APPENDIX K

SLR Consulting Peer Review – Air Quality and Noise

**Independent Peer Review - Air Quality Assessment
Proposed Resource Recovery Facility
Queanbeyan West**

**Independent Peer Review - Noise Assessment
Proposed Resource Recovery Facility
Queanbeyan West**

Figure 2 Locations of Identified Sensitive Receptors

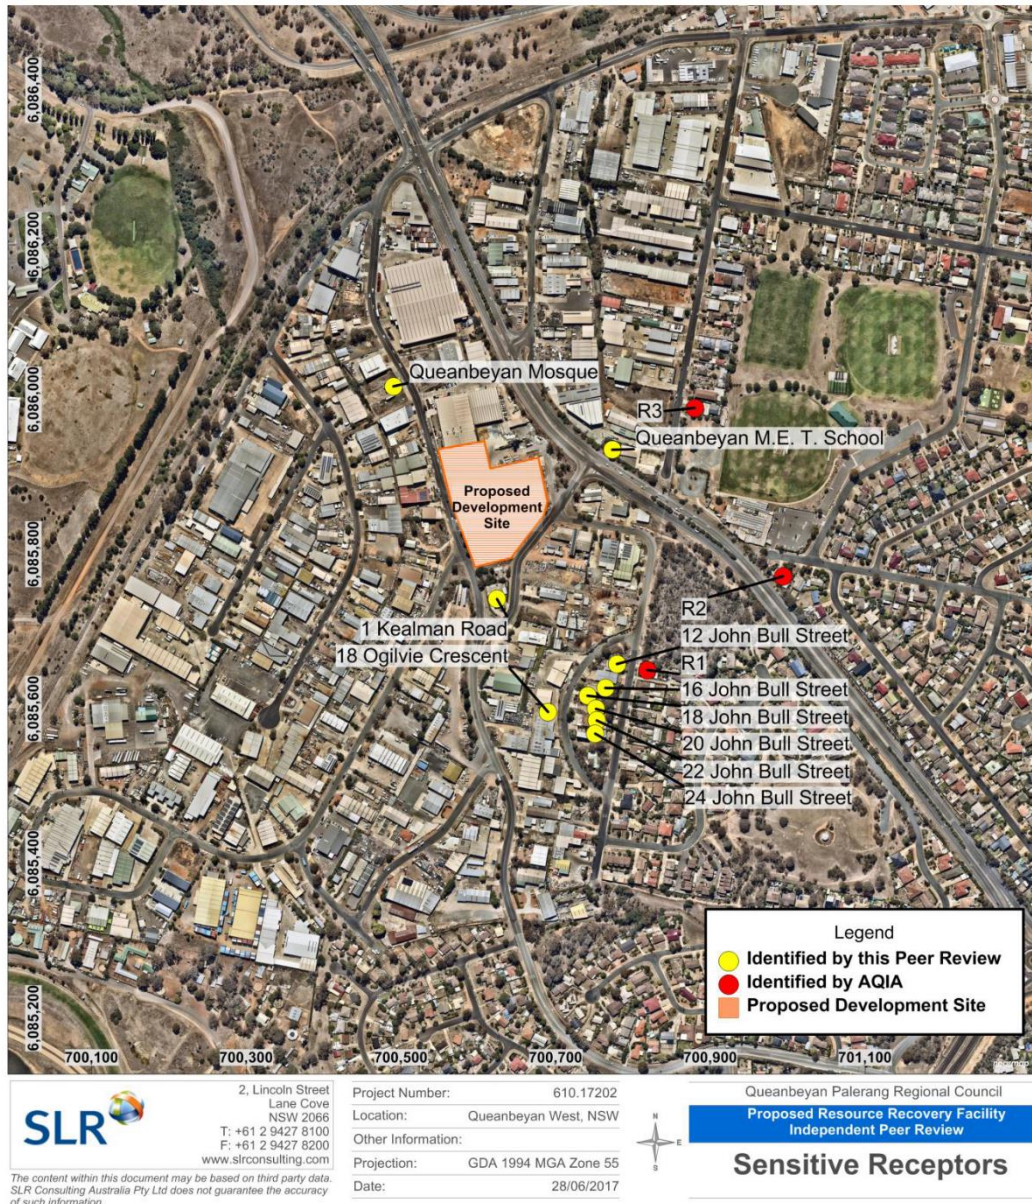
During the site visit, additional sensitive receptors located closer to the Proposed Development Site than those included in the AQIA were identified. This included a mosque, a school and several caretaker dwellings. **Figure 2** illustrates the location of these sensitive receptors in relation to the sensitive receptors identified by the AQIA and the Proposed Development Site.

- According to the Approved Methods a sensitive receptor is "A location where people are likely to work or reside; this may include a dwelling, school, hospital, office or public recreational area". Several sensitive receptors including a number of caretaker dwellings (closest is less than 40 metres (m) from the site), a mosque and a school are closer to the Proposed Development Site than the sensitive receptors identified by the AQIA. Air pollutant/odour concentrations have not been assessed for these sensitive receptors. It is noted that according to the EPA's General Terms of Approval, residents within an industrial zone are treated as industrial receptors for the purposes of noise assessments, but not for air quality assessments.

Figure 2 Locations of Identified Sensitive Receptors

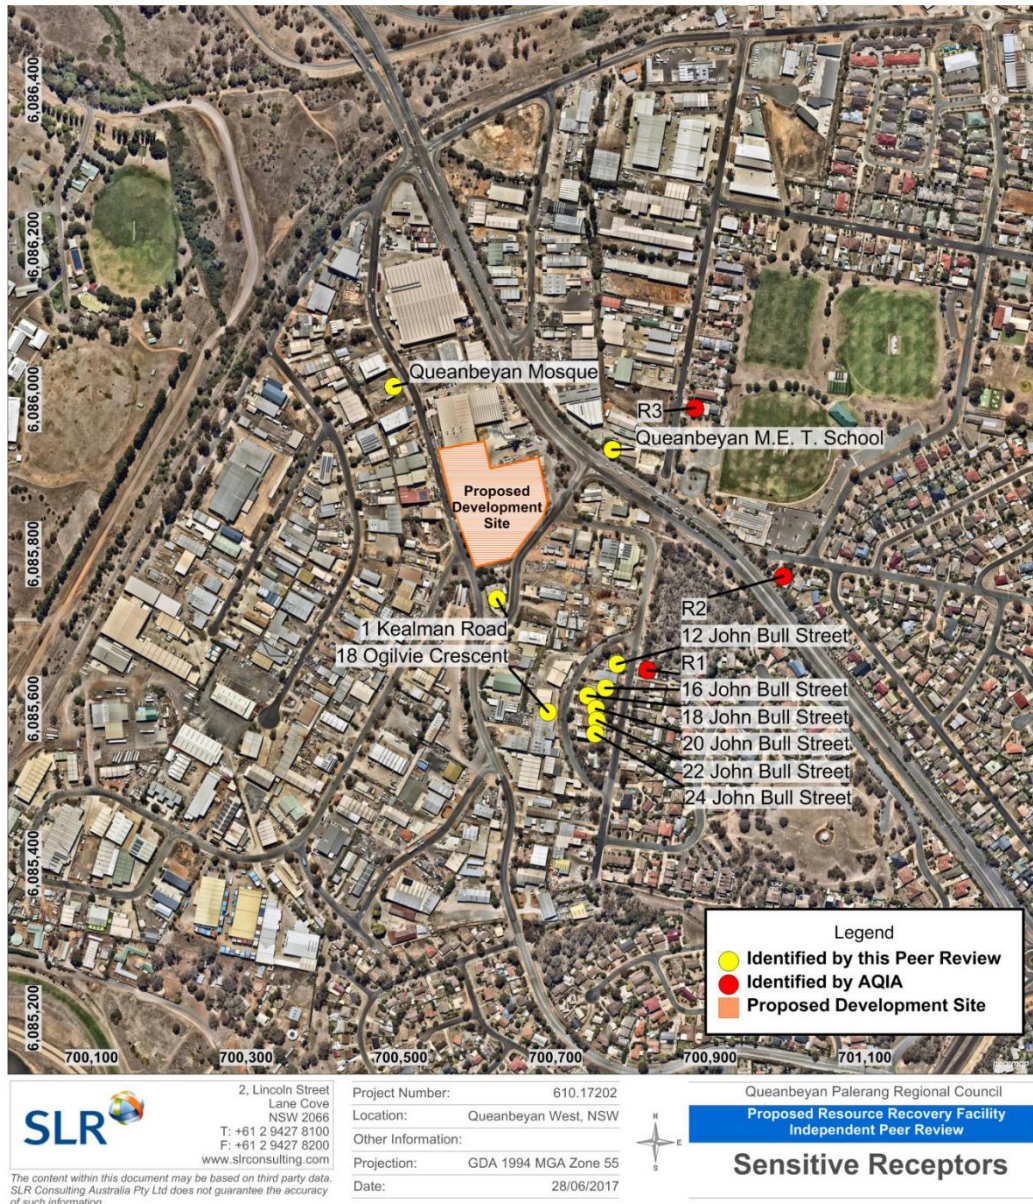
During the site visit, additional sensitive receptors located closer to the Proposed Development Site than those included in the NIA were identified. This included a mosque, a school and several caretaker dwellings.

Figure 2 illustrates the location of these additional sensitive receptors in relation to the sensitive receptors identified by the NIA and the Proposed Development Site.

ID	Reference	Comment	Significance
Noise and Greenhouse Gas Assessment, Proposed Resource Recovery Facility, Queanbeyan West (February 2015)			
1	Section 2.1, Page 1	Identification of Sensitive Receptors Residences located to the east of the project site were identified by the NIA as being the nearest sensitive receptors. Sensitive receptors closer to the project site were identified during the SLR site visit. It is noted that these receptors are located in an area zoned for industrial activity (see Figure 1). However, the Council has confirmed that all identified sensitive receptors are approved premises and therefore fall within the Approved Methods definition of sensitive receptors. The Approved Methods defines a sensitive receptor as "A location where people are likely to work or reside; this may include a dwelling, school, hospital, office or public recreational area". The identified residences confirmed by the Council as having approval are illustrated in Figure 2 and include the following: - School: 67 Lorn Rd, Crestwood NSW 2620 - Mosque: 185 Gilmore Rd, Queanbeyan West NSW 2620 - Caretaker's dwelling : 12 John Bull Street, Queanbeyan West NSW 2620 - Caretaker's dwelling : 16 John Bull Street, Queanbeyan West NSW 2620 - Caretaker's dwelling : 18 John Bull Street, Queanbeyan West NSW 2620 - Caretaker's dwelling : 20 John Bull Street, Queanbeyan West NSW 2620 - Caretaker's dwelling : 22 John Bull Street, Queanbeyan West NSW 2620 - Caretaker's dwelling : 24 John Bull Street, Queanbeyan West NSW 2620 - Caretaker's dwelling : 18 Ogilvie Crescent, Queanbeyan West NSW 2620 - Caretaker's dwelling : 1 Kealman Road, Queanbeyan West NSW 2620	Medium
